A REVIEW OF PART I OF EXPLANATORY HANDBOOK ON CODES FOR EARTHQUAKE ENGINEERING

Part I of the Explanatory Handbook on Codes for Earthquake Engineering published by Bureau of Indian Standards has been critically reviewed. Suggestions are given for enriching contents of the Handbook in its next edition. Some of the solved examples in the handbook require corrections and these are mentioned. Some examples have debatable assumptions and these have been solved by the finite element method to check validity of such assumptions and suitable modifications are suggested. Finally, typographical errors that have not yet been included in the errata available with the handbook are listed in the appendix.

Fig. 1 Assumed Faijure Line due to Overturning

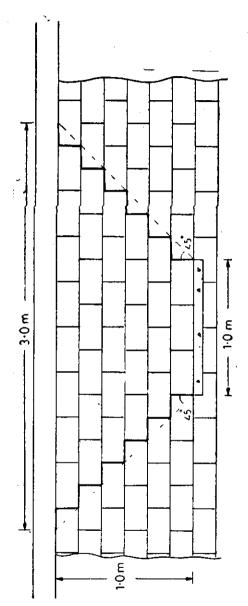
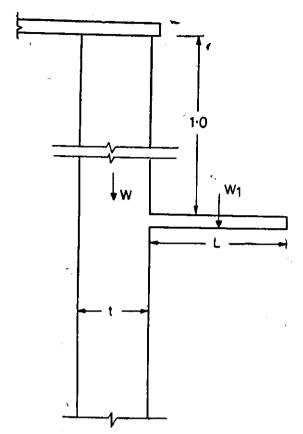
The following points relate to Example (5) of the handbook. On page (19) weight of roof slab per metre run including finishes is given as 0.8t. But the following calculations show that it is 0.62t.

This example has been reworked out with the assumption that the failure plane in the wall makes an engle of about 45° to vertical on either side of the cantilever (Fig. 1). This is more realistic than the assumption of vertical failure lines made in the handbook.

With reference to figure (2), stabilising moment is given by

$$W = 0.8 + 0.62$$
= 1.42t
$$M_s = 1.42 (1-0.2) \times 0.2/2$$
= 0.1136 t.m.
Factor of safety against
everturning = $\frac{0.1136}{0.0864}$
= 1.31>1

Hence O.K.
